# SERVICE INSTRUCTION

Service Instruction No. 1514D  
(Supersedes Service Instruction No. 1514C)  
Engineering Aspects are  
FAA Approved

SUBJECT: Roller Tappets Part Information Update

**Figure 1**  
**Roller Tappet Assemblies**

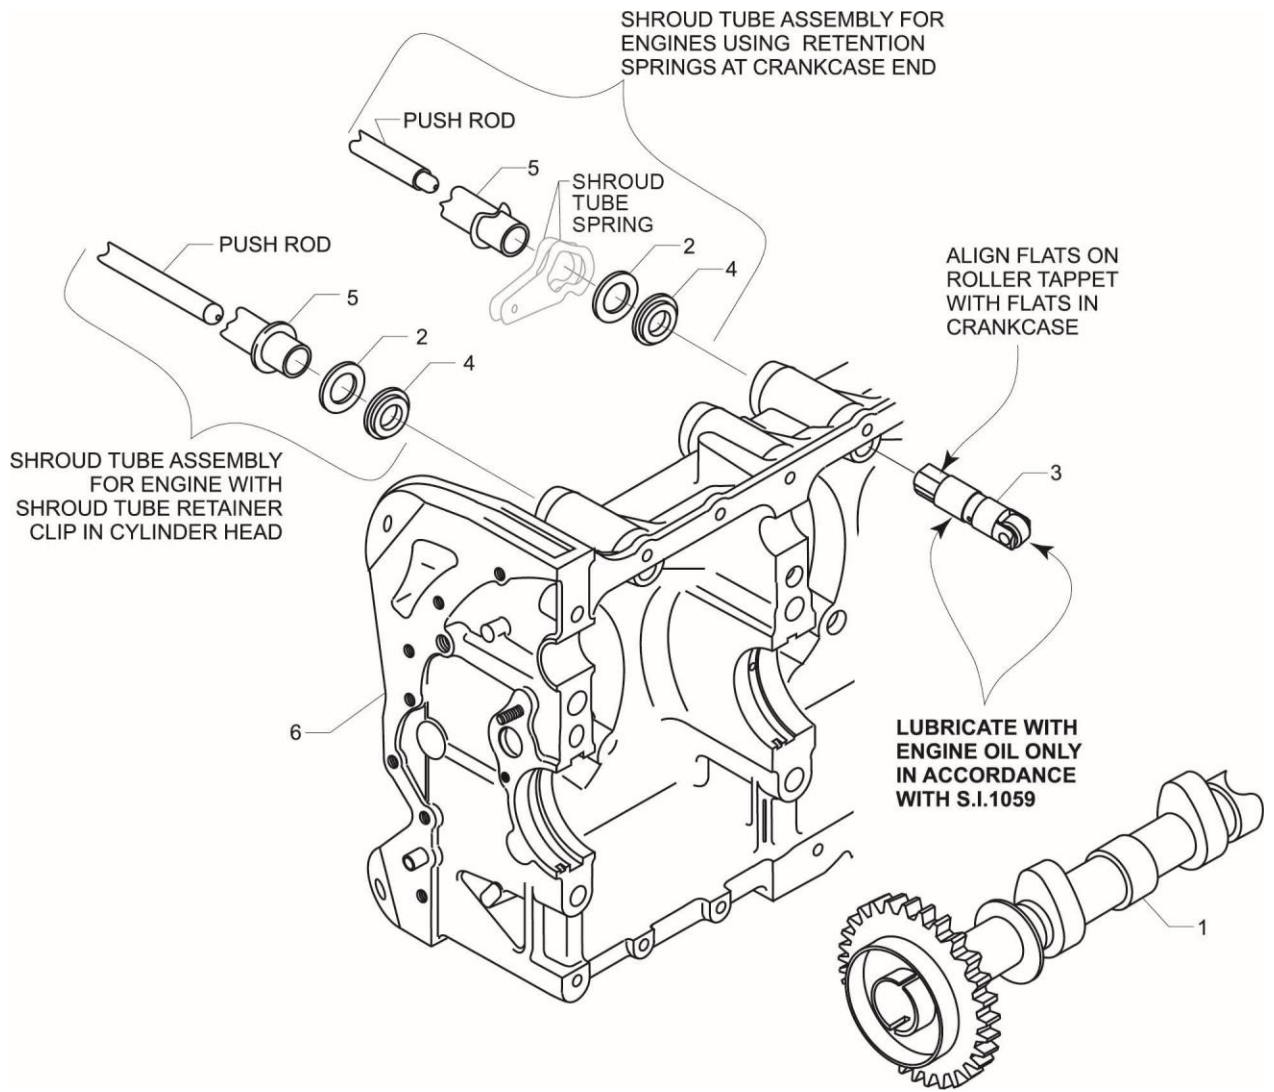
REASON FOR REVISION: Removed shroud tube springs from Tables 1 and 2; update to Figure 1; P/N updates on page 2

**WARNING:** ROLLER TAPPET PARTS ARE NOT INTERCHANGEABLE WITH CURRENT FLAT FACED TAPPETS.

If it is necessary to remove the roller tappet bodies prior to overhaul, they **must be reinstalled in the same location in the crankcase.** The roller tappets are indexed with flats in the new crankcase. It is possible to assemble the roller tappet bodies in two different orientations 180 degrees apart. Either orientation is acceptable while reinstalling. Lubricate all tappet bores, cam lobes and roller tappets with engine oil mixture only. (Refer to the latest revision of Service Instruction No. 1059.) Install the shroud tube seal in the crankcase, then install the shroud tube.
